AVON ROAD: PROPOSED WAITING RESTRICTIONS**RECOMMENDATIONS FOR AMENDMENTS TO PROPOSALS****Avon Road, Devizes**

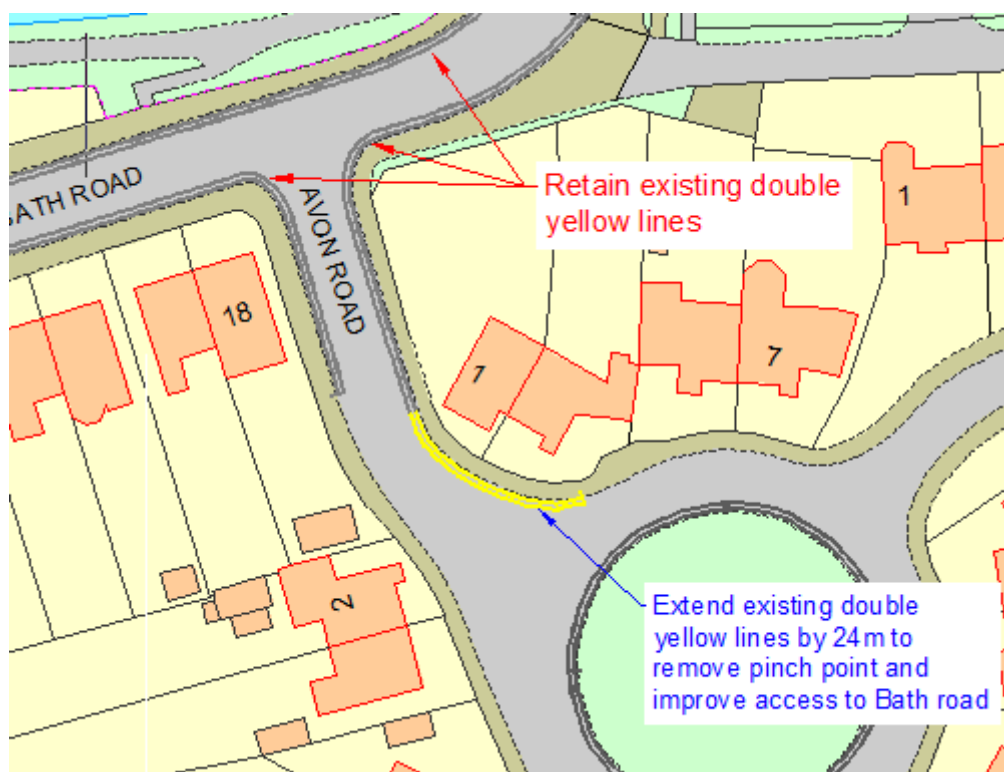
Reduce the extent of Double Yellow Lines to the East by 5 metres to allow parking to the front of accesses. This reduction is not expected to affect the overall proposal to remove the pinch point at this junction.
